SUSQUEHANNA STEAM ELECTRIC STATION, UNIT 1

AMENDMENT TO FACILITY OPERATING LICENSE

Amendment No. 69
License No. NPF-14

SUSQUEHANNA STEAM ELECTRIC STATION, UNIT 2

Figure 3.1.5-1

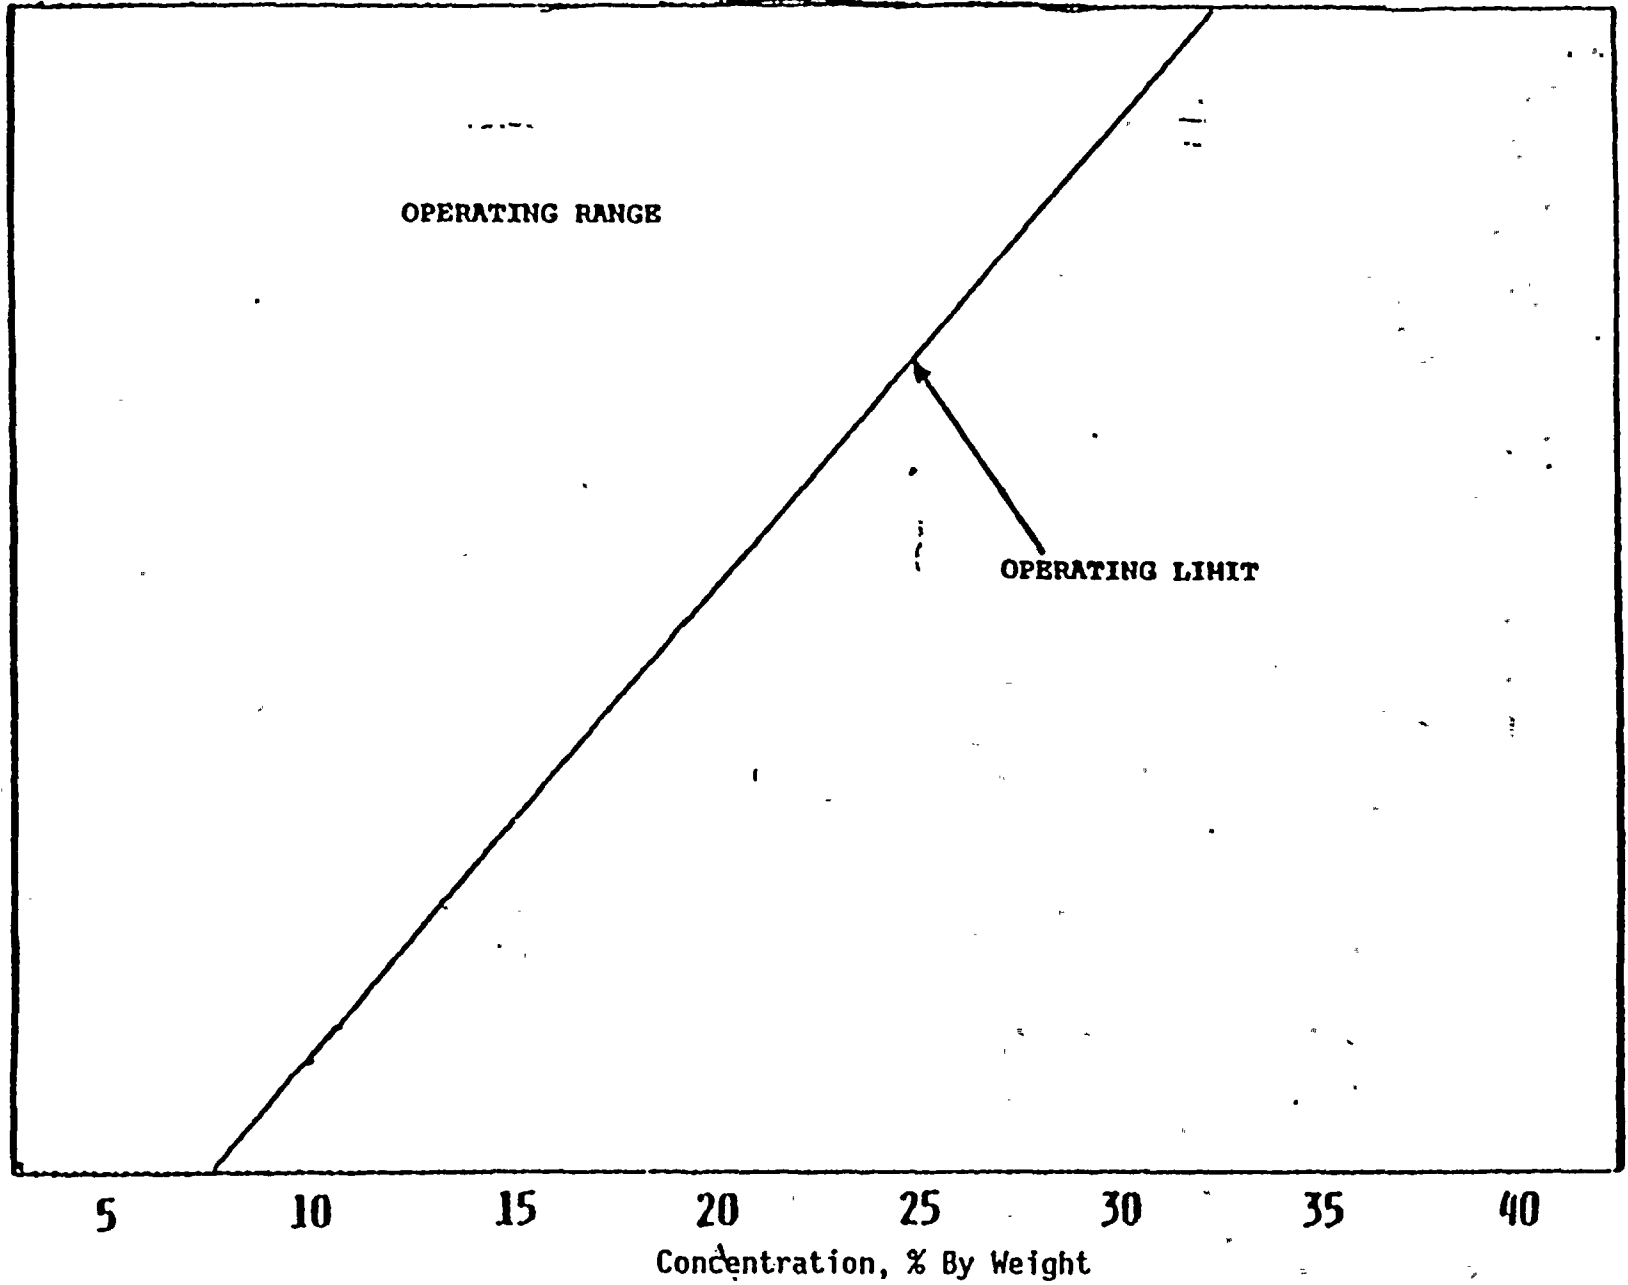
Replace the following page of the Appendix A Technical Specifications with enclosed page. The revised page is identified by Amendment number and contains vertical lines indicating the areas of change. The overleaf page is provided to maintain document completeness.*

FIGURE 3.1.5-1

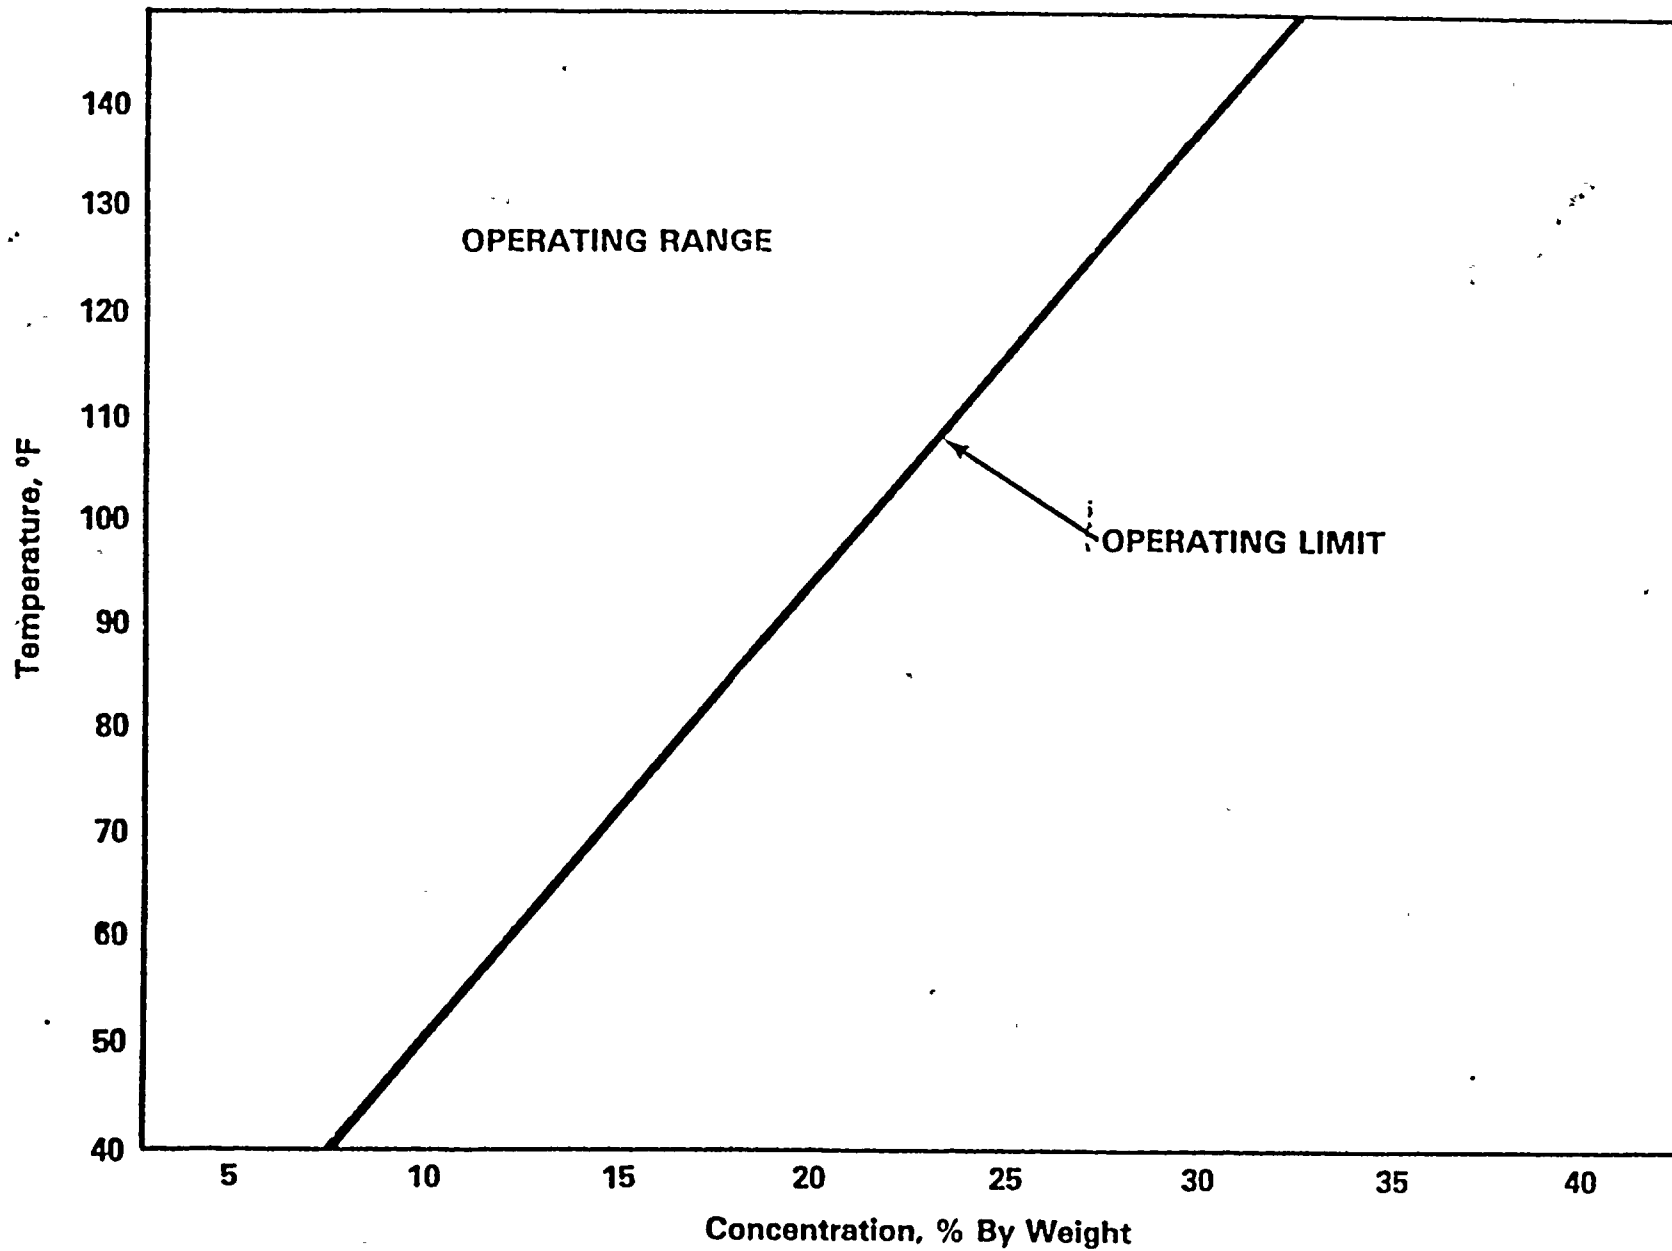
Replace the following page of the Appendix A Technical Specifications with enclosed page. The revised page is identified by Amendment number and contains vertical lines indicating the areas of change. The overleaf page is provided to maintain document completeness.*
